Revision of Manuscript Number: IEEE-TPWRS-01391-2021, version 1 January 1, 2022
Journal: IEEE Transactions on Power Systems
Author: Abhishek Halder, Kenneth F. Caluya, Pegah Ojaghi, Xinbo Geng

Response to decision:

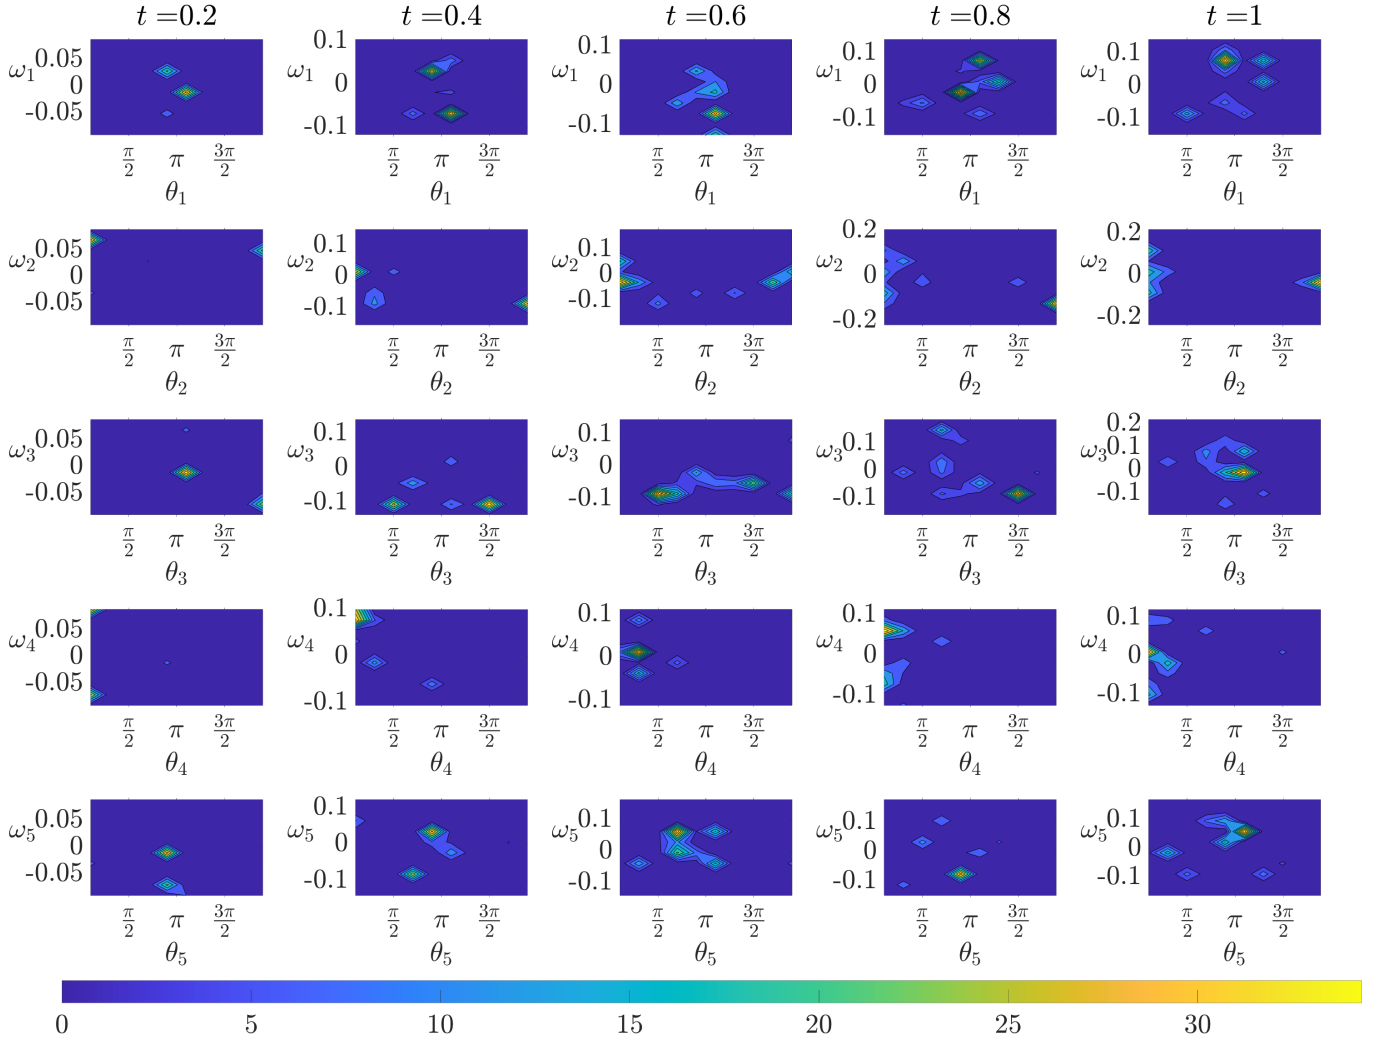
Figures 5 and 6 are unreadable.

Response: Thanks for this comment. In the previous version, the strict 10 page limit enforced small figure sizes. In the revised manuscript, Figures 5 and 6 are made larger. Also, the Fig. 6 in the revised manuscript shows the transient (θ_i, ω_i) bivariate marginals for all the five generators in Case II; the previous version showed the same only for the generator 4 (bus 6). We believe these changes have improved clarity.

Regarding the style of plots, we had considered plotting the bivariate marginals as planar contour plots (as in Fig. 1 in this rebuttal document) but decided against it because of the following two reasons.

First, in our opinion, this kind of plot is scientifically misleading as they hide the fact that these bivariate marginal PDFs are not really supported on the plane, or the subsets thereof, but instead have cylindrical supports. Our message that the proposed method explicitly accounts this manifold geometry in the computation, would be missed had we chosen to make the plots as per populist cognitive bias on behalf of the readers. That the planar plots evoke a sense of familiarity cannot be a scientific argument in favor of it.

Second, the planar contour marginal plots require additional mental efforts from the readers to correctly parse the statistical information conveyed. For instance, consider the fourth column, second row subplot in Fig. 1 in this rebuttal document. It is upon the reader to parse that the two high probability regions on the left and right of that subplot are actually referring to the same angular high probability region around $\theta_2 = 0$, thanks to the periodic boundary condition on the angular variable. Our philosophy of technical communication is that the onus is on the authors, not on the readers, to present the scientific information as correctly as possible. And yes, we are aware that many papers in the power system literature make plots in the rectangular domain ignoring the manifold nature of the support, which in our experience,

continue to add pain to the graduate students and beginning researchers trying to understand the statistical meaning conveyed in those plots. We prefer ours not be another paper contributing to the accrual of such.
